August 1, 2008

# SUBJECT: Public Notice 2004-28820N – Gualala River Gravel Mining, Sonoma County, California

# SUBJECT: Gualala River gravel mining (File No. UPE04-0040, Gualala Instream), Sonoma County; Draft Negative Declaration (California Environmental Quality Act) general comments

SUBJECT: Gualala River gravel mining (File No. UPE04-0040, Gualala Instream), Sonoma County; Draft Negative Declaration (California Environmental Quality Act) comments regarding significant impacts of 2005 unauthorized gravel mining to channel stability and fish habitat quality at the confluence of the South Fork and Wheatfield Fork, Gualala River.

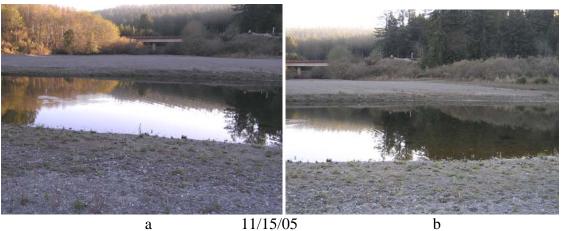
edge; <u>incipient infilling of thalweg</u> occurs while the top of the low, flat, degraded gravel bar conveys and dissipates high flows rather than confine them mostly within the previously channelized profile. Note low turbidity (lack of recent rainfall)

01/02/06. **INCIPIENT CHANNEL SWITCHING**. View downstream from Wheatfield Fork confluence following recent high flows (note high turbidity). Terminal South Fork bar is degraded to low sand/gravel flats within and above the 2005 mining pit, where sediment recharge is failing. Thalweg remains at traditional eastern edge of terminal South Fork bar, but the degraded bar is developing branched channels, gravel/sand lobes and fans across the 2005 mining pit, dissipating high flows, and initiating progradation of the bar edge across the thalweg.

11/15/05

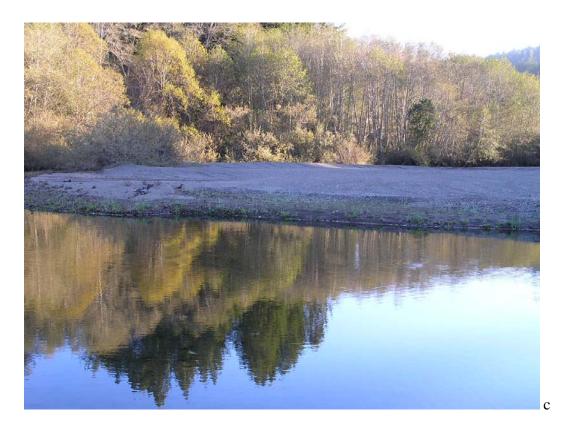
11/15/05. View upstream from Wheatfield Fork confluence, showing degraded post-mining condition of South Fork terminal bar. Note flattened, sloping, low bar crest elevation (less than 0.5 m above water surface in late fall low flow condition) along Wheatfield Fork and bank of South Fork channel. Note also the graded, mined bar edges (c; pushed into willows along edge of bar, towards South Fork thalweg; excavated area extends to within approximately 4-5 m from edge of South Fork channel at confluence point!) establishing topography for an efficient flow path during high flows that overtopped the terminal South Fork bar in January-April 2006. Note tire tracks persisting on gravel flats; no flows have yet overtopped the degraded bar.
